# **APPENDIX C**

## **Stakeholder Feedback Session on Design Scenarios – September 30, 2013**

**54<sup>th</sup> Street Reconstruction  
and Arden Park Stormwater  
Management Plan**

### East, Scenario 1: Highlights and **Unique** Features

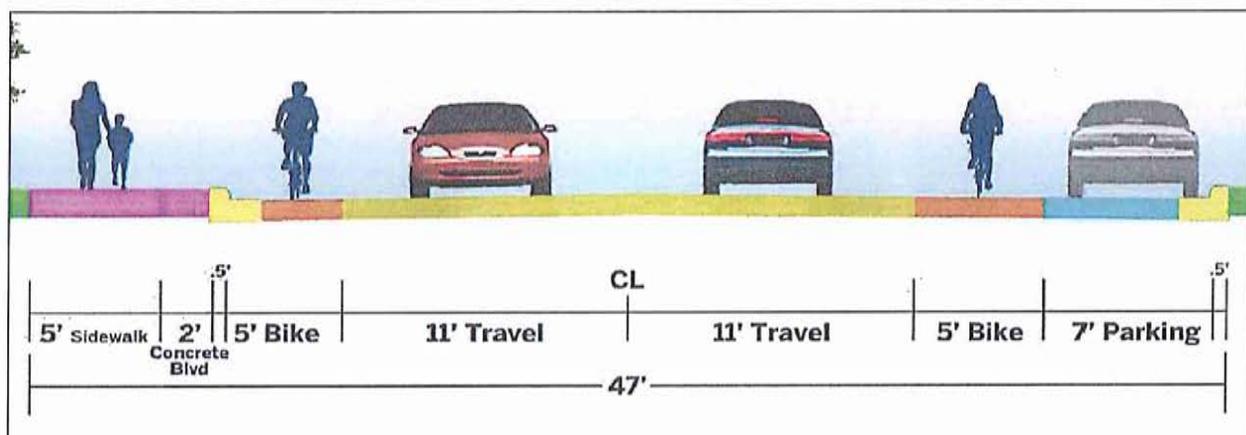
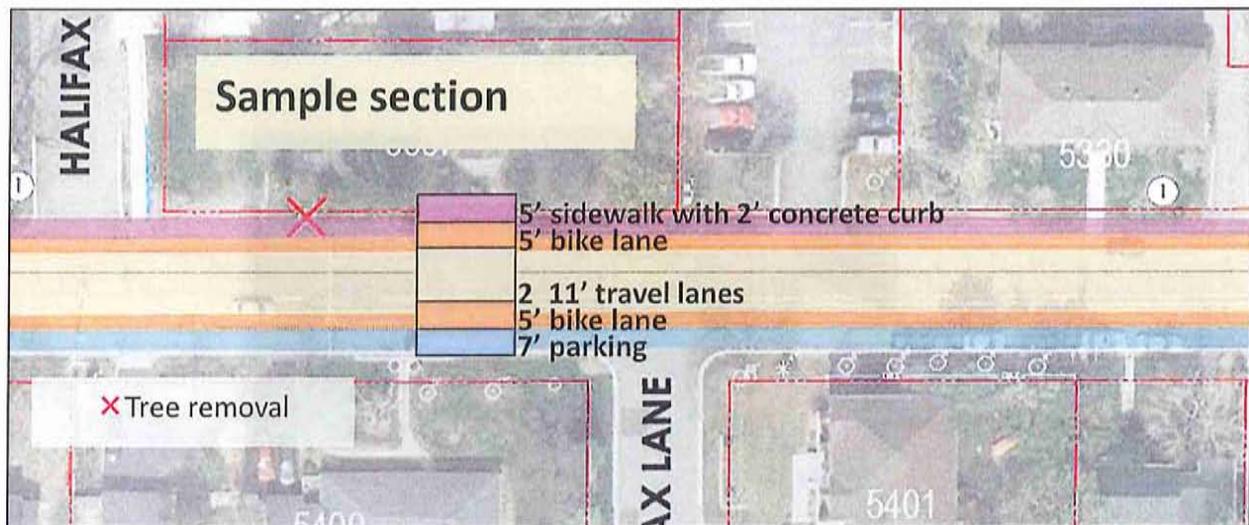
- Prefer #1 over the other two scenarios. Like sidewalk on one side, like street width same versus changing
- Love the sidewalk
- Sidewalks, bike lanes, clear parking lane

- Sidewalk on north side.
- This layout seems to be a very logical way to arrange the street for all types of users and drivers. Bike lanes for each direction are a good idea.

- Need width for winter. Too narrow at Minnehaha boulevard
- Limit the number of bus stops, less rather than more
- Too wide. Put sidewalk in south side, no dedicated bike lanes

- No dedicated bike lines
- No bike lines or lanes
- No dedicated bike lanes
- Too wide! No dedicated bike lanes please
- Don't like 3 (too wide). Scenario 1 or 2 are preferred

- Consider permeable application for 2' boulevard
- Minimize tree removal
- Width of street; don't need dedicated bike lanes; 2' concrete curb is ugly and takes away from appealing greenery

- Do not need dedicated bike lanes for rarely used bike traffic.
- No to bike lanes, no bike lane lines -- impedes driving & unnecessary in winter
- 11Foot Travel Lanes are not wide enough. Will have same problem as we had on Wooddale.

- 2 feet for a concrete boulevard? Why is this necessary?
- Why take parking away (north side) and replace with dedicated bike lanes? (they are NOT required on a secondary route); with the exception of Sunday (church) and isolated evenings those parking lanes will be empty and can be utilized by bicyclists

- We can't accommodate the same width on the west side of 54th Street
- Adding the permanent parking lane adds to an excessive road width
- I think the sidewalk has been put on the wrong side of the street. It should be on the south side. People use the south side of the street to go the Lutheran church and the convenience store at 54th and France. I rarely see people walking to Arden Park along this part of 54th Street.

- Can we better control speeders?
- Why do we need a street this wide?
- Do area residents get a final say? Is there a town hall meeting for resident input, to be heard by city council & engineers?
- why not have two 13.5' shared bicycle/travel lanes
- I am intentionally not weighing in on this section because the opinions of those directly impacted by the scenarios are the only people who should be listened to.
- Loss of tree (against Living Streets Policy)
- Has the church been contacted to get on board with the design?

- Can you consider using the bike lane(s) for Sunday parking?
- Why can't you have a shared-lane (bike/motorist) concept along entire 54th Street? Keep it simple and consistent the entire length; reduces confusion among bicyclists/motorists
- What means of injunction have you prepped if they proceed with turning the southeast corner into a blacktop wasteland that essentially scuttles your and the residents well thought out planning?
- When are the parking lanes most utilized?

## E1 Bus pad

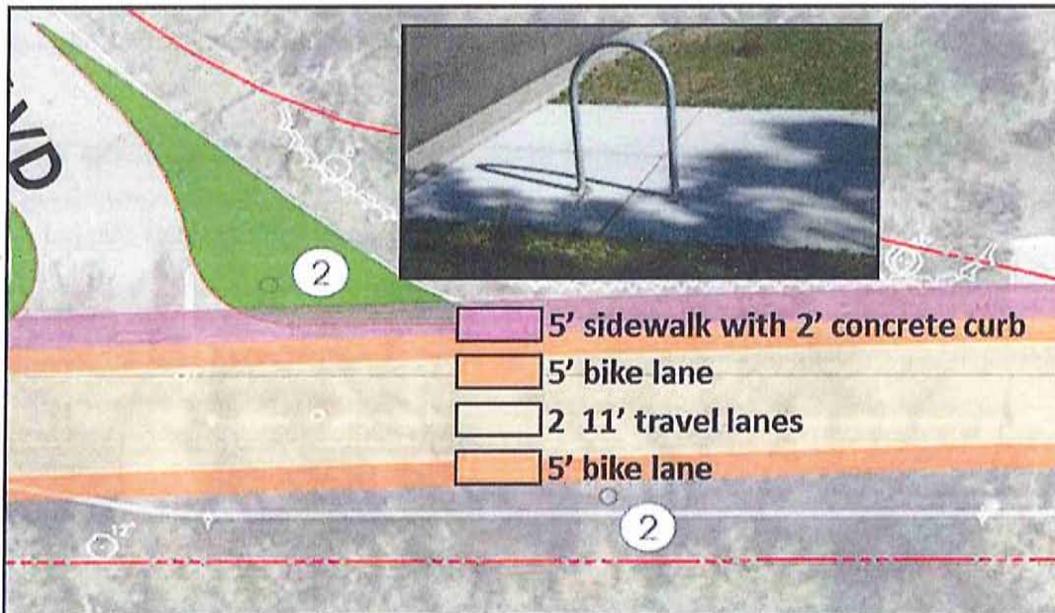
- Bus stop pad not needed or wanted. Nobody uses this location. Don't make pad
- Bus stop pad not needed
- Don't need to add pad; use sidewalks including Church's
- No bike rack/pad here. Check with Metro Transit to eliminate stop due to low use?
- NO! These concrete slabs are ugly and totally unnecessary for the # of bus riders that this street has.
- No, those bus stops are rarely if ever used.
- yes to concrete pad on south side (for eastbound buses)
- Good
- This will be very helpful in winter for bus-users
- no
- no
- No, more concrete, more runoff
- Good
- Better defines the bus stop...keeps riders off the road; would seem to be a good idea
- No pad needed or wanted
- No bus stop bike pad here. This bus stop is never used. South side of 54th and Halifax (by power pole)
- Absolutely no and never used
- Ugly - don't need slabs of concrete

### East, Scenario 2: Highlights and **Unique** Features

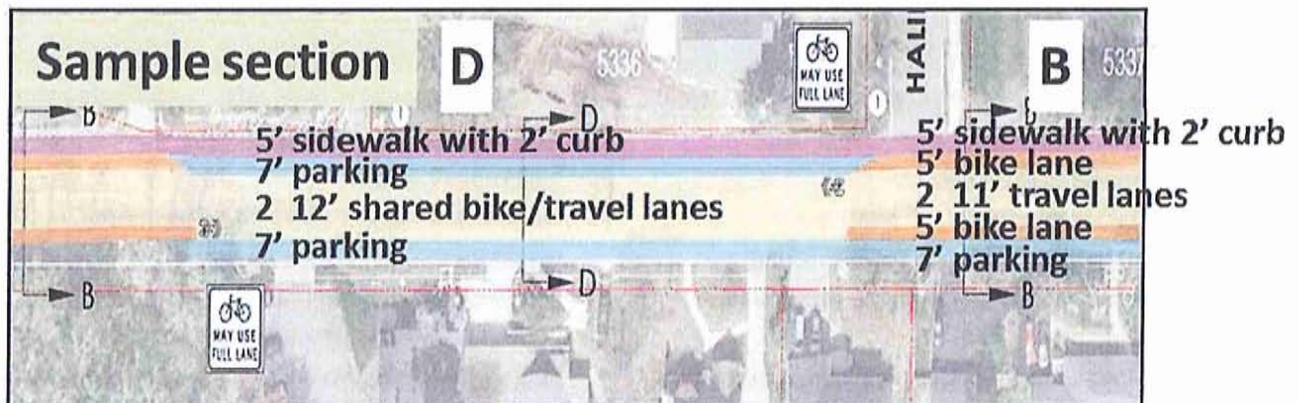
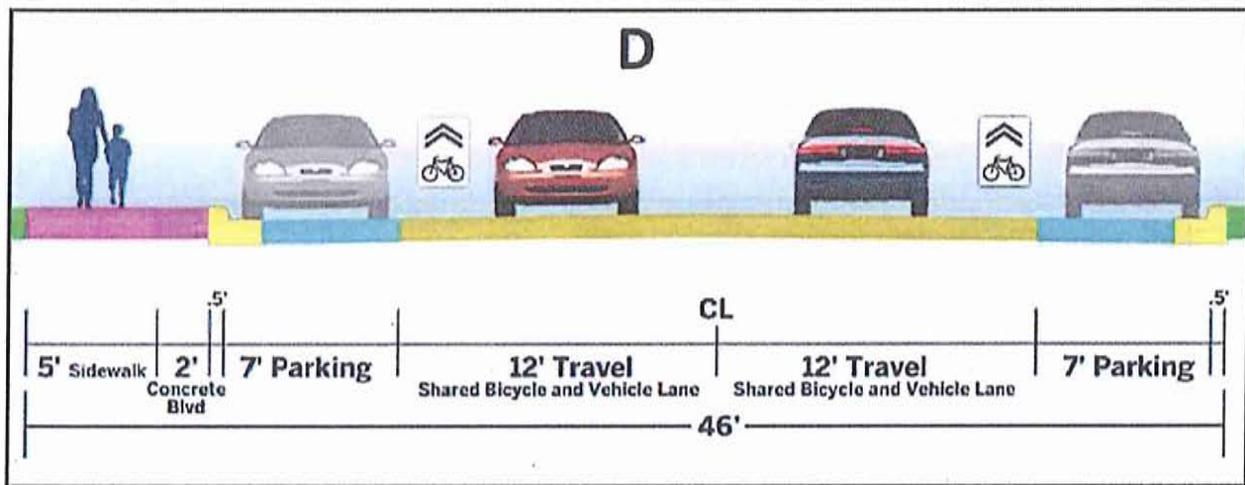
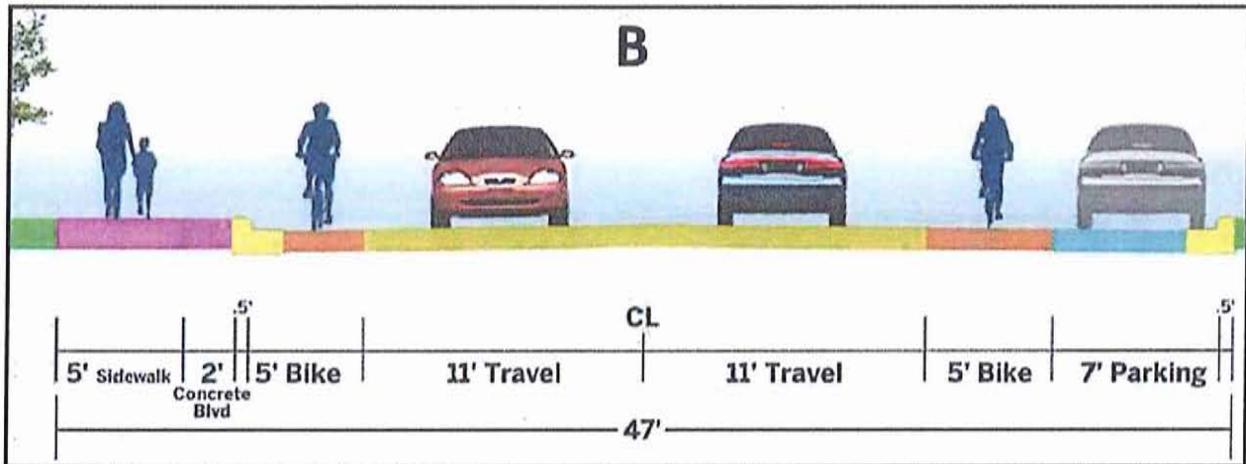
- Need boulevard; can it be green? Flowers/native plants?
- Key is historic. #2 is best
- Scenario 2 is preferred
- 4015 W 54th street like this option Scenario 2
- Edina should be a leader in being bike friendly
- We like this best of all!
- Parking both sides of street with shared bike lanes.
- yes to sidewalk on north side of 54th
- width of street
- north side parking only at the church
- Keeping parking on both sides would help meet church's parking demand
- Shared bike lanes
- Shared bike lanes. Sufficient parking for neighborhood (like church)
- 4015 west 54th street likes this option the best.
- yes to center lines for cars on 54th
- Shared-lane bike/travel reduces need for additional width, while still providing with bike route
- sidewalk

- Is boulevard needed? No 2' boulevard
- Don't like dedicated bike lanes. Prefer parking here
- Consider sidewalk on west side of Minnehaha
- Love "share the road"; dedicated bike lanes are not needed given bike traffic
- As narrow as possible, 11' lanes, please line all others
- Ideal is narrow street shared with bikes, two-sided parking, no sidewalk boulevard
- Less signs, no flashing lights

- Sidewalk needs to be on the church side. South side sidewalk is there
- Sidewalk does not need to be on the south side
- Sidewalk on north side, why?
- No need for dedicated bike lanes, parking instead

- Either bike traffic benefits from dedicated lanes, or it doesn't. If it does, then the lanes should be continuous and not displaced by parking to serve the church. If bike lanes are not indicated then why include them? You're sending mixed messages not only to cyclists who will have to change their path to avoid parked cars, but also to all of us who want to understand the criteria for adding bike lanes.

- Why introduce a 5' dedicated bike lane for one block? I would just continue with the shared concept all the way to France; KEEP IT SIMPLE

- Parking counts. Is parking needed on both sides?
- Narrower streets are safer...why are we focused on such wide streets?
- why not use two 13.5 shared bicycle / vehicle lanes

- Why do we compromise safe and convenient travel for all modes in order to provide on street parking?
- I would just flip the sidewalk to the south side and connect with the existing church sidewalk

- Have the designers explored creative traffic-calming measures along this part of the road? Curb bump-outs? to help define parking and produce pinch points to help slow traffic? This part of 54th is wider than the west side and drivers tend to drive a little faster at this point. The parking is used heavily on Sunday (obviously) and rarely when church doesn't have activities. The parking lane essentially becomes a bike lane when there's no cars present. Why not kill two birds with one stone? I think more can be done to help make this end of 54th tie in more closely with the west side and make more cohesive. PLEASE explore this possibility!

### East, Scenario 3: Highlights and **Unique** Features

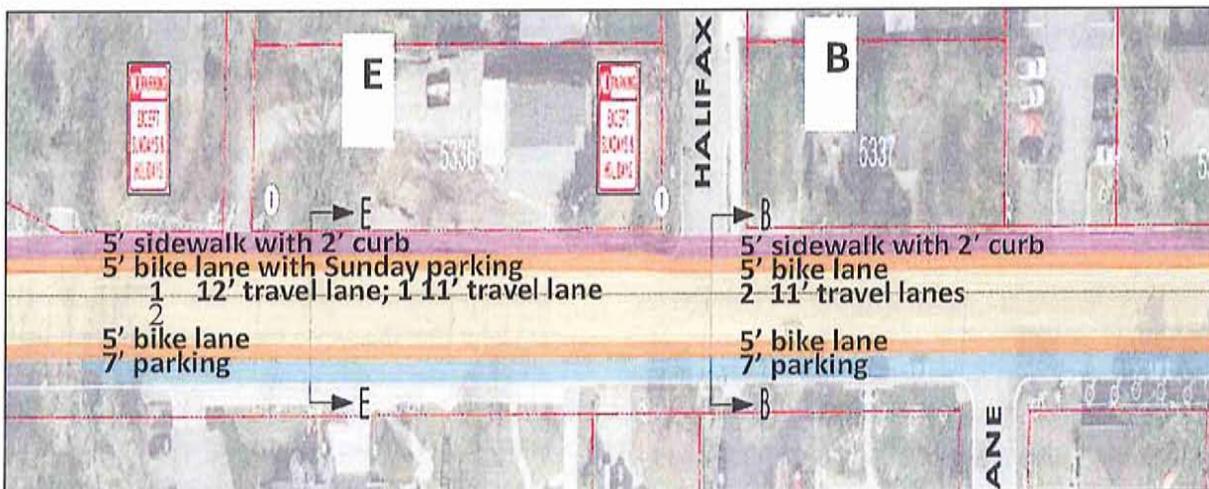
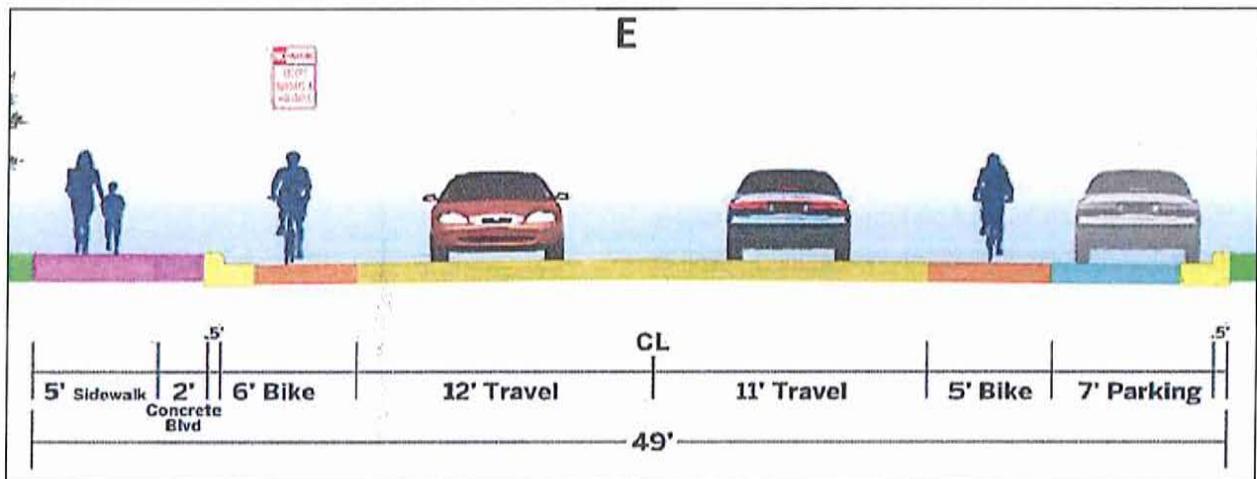
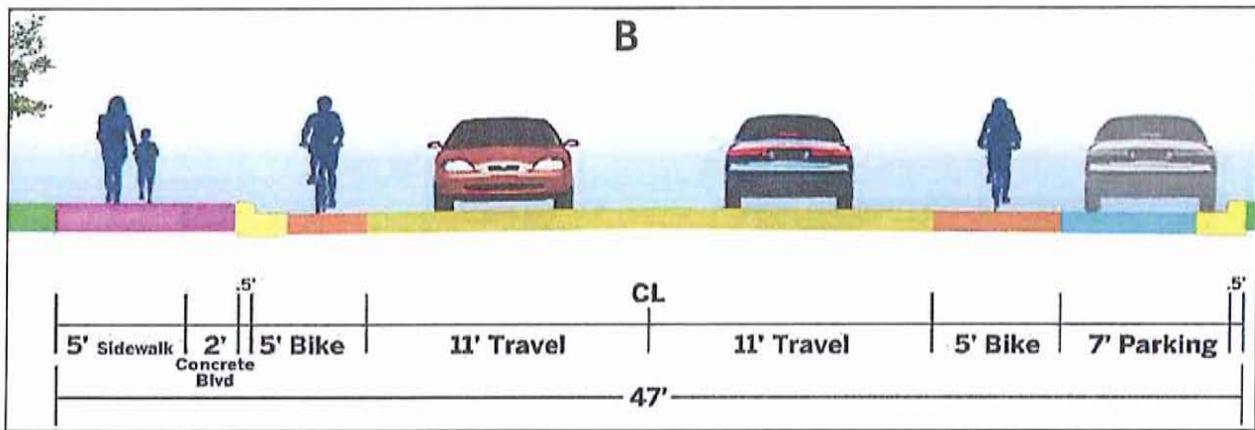
- Like reducing speed of turn to Minnehaha Blvd
- Yes to sidewalk the entire distance
- Yes to option of bike lane/parking on Sundays
- Scenario 3 best options for all!
- Parking on Sundays is a good idea (like at Mt. Olivet)
- I prefer the Scenario 3 plan
- Parking on Sunday but prefer D
- Nothing
- parking only on south side
- no parking on north side of street
- Dedicated bike lanes.
- shared bike lanes

- Scenario 3 is too wide
- Move bus stop to in front of the church
- Too wide! Go to sharrows all the way through
- No dedicated bike lanes. 11' lanes please

- No dedicated bike lanes. Parking both sides
- Sidewalk should be on the church-side of the street
- Sharrows is necessary. No dedicated bike lanes
- Too much emphasis on bike lanes; very little used and they do not follow rules of the road

- Narrow as possible! Do not widen more than existing
- Reduce signage - too many
- We do not need bike lines in the road
- Keep bucolic feel please!
- Opposed to Sunday-only parking, or parking in bike lanes ever

- Again, why would we put on street parking ahead of bike lanes IF we believe bike lanes are indicated by traffic volumes (and they are) and other factors?

### E3 Questions, comments

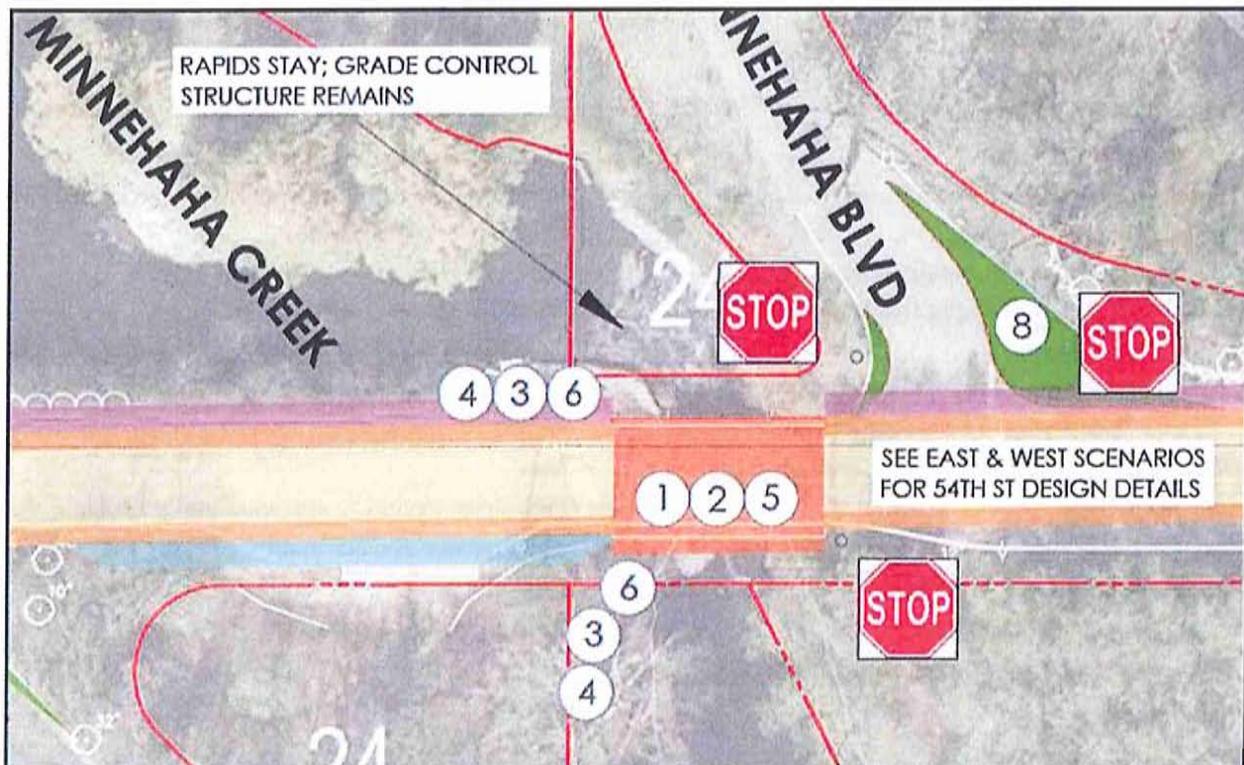
- How do we reduce speed on 54th?
- Why do we need 2 dedicated bike lanes - why can't they share the travel lane?
- why not provide two 13.5 shared bicycle / vehicle lanes
- What is a holiday? For example can I park there on Yom Kippur? How about MLK Jr. day? Once somebody complains, it will be difficult to enforce.
- 5' bike lane with Sunday parking? Why not have a dedicated parking lane that is occasionally used by bicyclists? This stretch of the road will RARELY have the parking used, allowing for 7' to 8' of wide open space for bicyclists; you don't need to have a dedicated bike lane
- Why do we need such a wide road?
- Why have a 2' concrete boulevard?
- Show existing homes/easements in your renderings. Widening road removes trees, utility poles, etc.

## 2 Views of raised bridge with shelf underneath

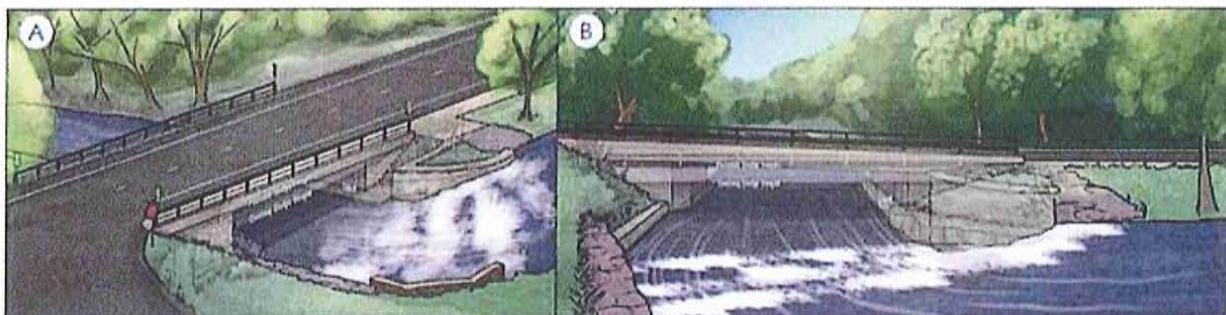
- Good idea to dredge creek and do what you can do clean it up
- Make creek visible to auto and foot traffic
- Remove all buckthorn and all else that is not a real tree

- Prefer Scenario 1 to 2
- I really like Scenario 1 and the opportunity for canoe access
- I like the under-bridge walkway for portaging boaters
- Prefer scenario 1 over scenario 2. Keep rapids

- Good to raise bridge to not have to portage on 54th Street
- Keep bump-out parking
- I like #6 [grass pavers]
- I like grass pavers
- I like the shelf under the bridge

- Keep the rapids
- Keep the rapids
- Bridge design is uninspired. Needs character
- Increase the height of the bridge even more
- Get rid of the ugly faux-stone approaches to the bridge; replace with stones and appropriately-sized boulders

- this rapid is a great resource and I have enjoyed playing on these waves in my kayak many times and would hate to see this really fun spot go away
- May be difficult to provide sufficient width/height under bridge for carrying canoe (especially if on someone's shoulders carrying it solo).

- no side walk on bridge
- The current rapids are created by the gradient as well as the concrete apron under the bridge. I am assuming the apron will need to change with a new bridge. Please consult with whitewater park designers to see how best to replace the concrete apron with something safer while maintaining rapids that are desirable to whitewater boaters

## M1 Questions, comments

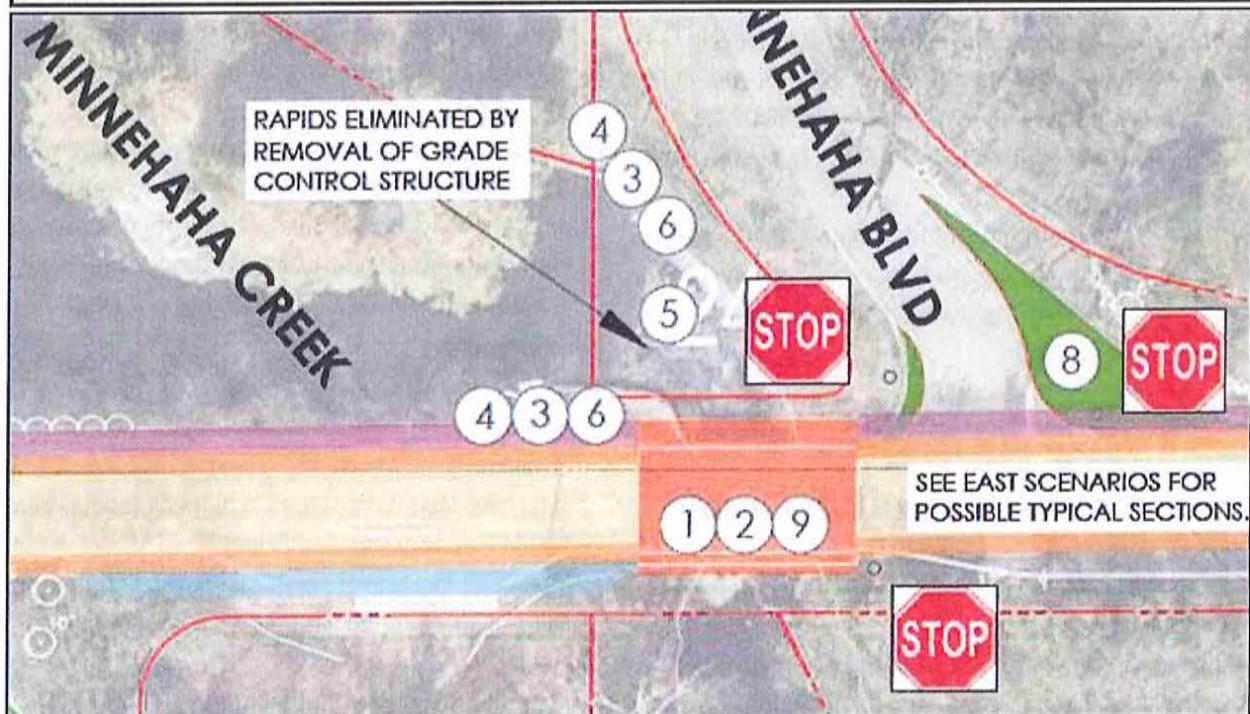
- Will raising the bridge cause icing?
- [On 54th facing Minnehaha] Possible canoe landing downstream left?
- Why is the street and bridge not curved to the south to add interest and calming effects and a better view of the rapids

- Why no sidewalk on bridge?
- I am intentionally not commenting on this section because the people most directly impacted should really be the only points of view that count.

ADDRESS CREEK SLOPE? (A) ROCK RIFFLE

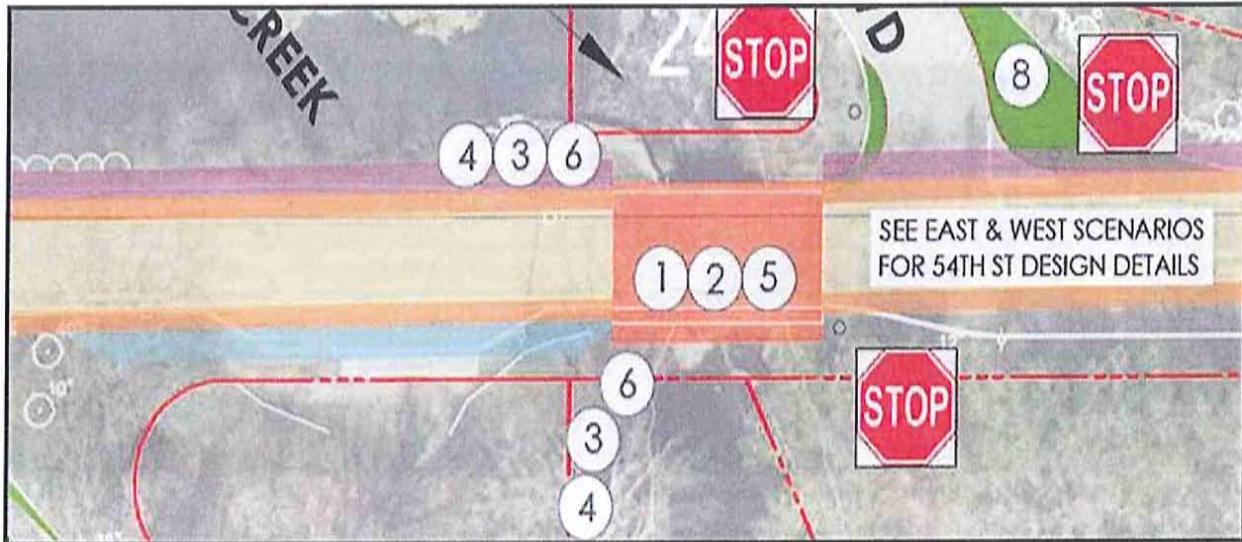
- No. This is a modification to the natural flow of the creek, ruins a fun feature for creek users, and is a waste of funding to address a nonexistent problem.
- Don't like that the rapids have been removed. I appreciate the challenge that they provide and enjoy how it is a break from the flatter sections.
- I like the rapids
- no
- no
- Does that dry up the creek upstream?
- No
- We want rapids
- don't remove the rapids
- DON'T TOUCH SLOPE! KEEP RAPIDS THE WAY IT IS!
- No - no - no!!! I have PERSONALLY witnessed fish making their way up the rapids as they now stand and seen 100's of schooling bullheads in the eddies!!!
